Specification & Drawing Change Notice

NO. A 0 0 4 0 8 1 2 - 1 / 2

Product: San Ace PWM Controller (BOX Type)

Model: 9PC8666X-S001

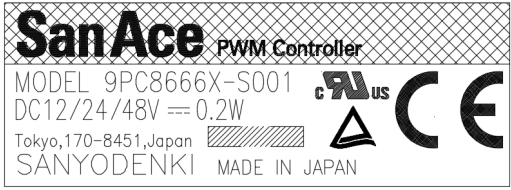
No.	Contents	Before	After	Description
1	Addition of Safety standard mark.	Please refer to the attached document.	Please refer to the attached document.	Safety standard marks will be added on fan label since the approvals were obtained.
2	Addition of ceramic capacitors	Please refer to the attached document.	Please refer to the attached document.	Ceramic capacitors for protection against noise will be added on PWB to obtain safety standard approvals.
				There is no change for its performance by this modification. Implementation Date: Mid of April, 2018 Production.

Before	After
No. 1		
No. 2		Ceramic capacitors added • 1 uF x 4 pcs (1608 size) • 0.0047 uF x 1 pc (5750 size)
